**TOWN OF COLLIERVILLE**  
**GENERAL SERVICES DEPARTMENT**  
**Procurement Division**  
**MEMORANDUM**

**TO:** ALL PLAN HOLDERS - TC2024-19 "SHELTON ROAD WASTEWATER TREATMENT PLANT OXIDATION DITCH ROTOR REPLACEMENT"

**SUBJECT:** ADDENDUM #1

**DATE:** 4/11/2024

1. The following diagram shall be used as a design:

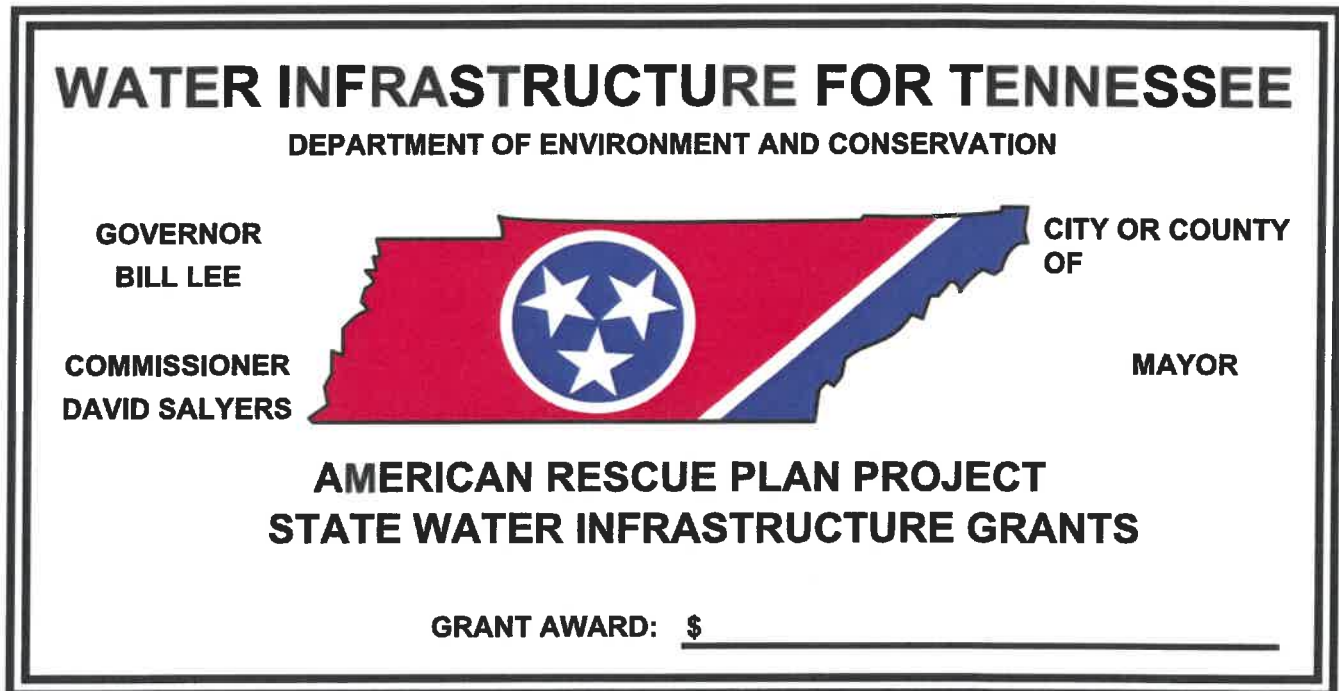
The cost of a project sign must be included in your lump sum bid. See page 2 of this addendum for a sign diagram to be used as the sign design.

All plans and specifications for each project approved shall contain provisions for requiring the general contractor to provide identification signs. The signs shall conform to the following basic features:

2. The sign shall be a 4'0" X 8'0" sheet of exterior grade plywood and shall be built so as to remain erected during the entire construction phase of the project.
3. The background of both sides shall be white. The lettering shall be black and shall be large enough to take advantage of the full size of the plywood. The stars shall be white set on a blue field and surrounded by a white ring placed inside a state map in red with a stripe of white and blue on the right side. The sign shall be bordered by a one-inch blue stripe.
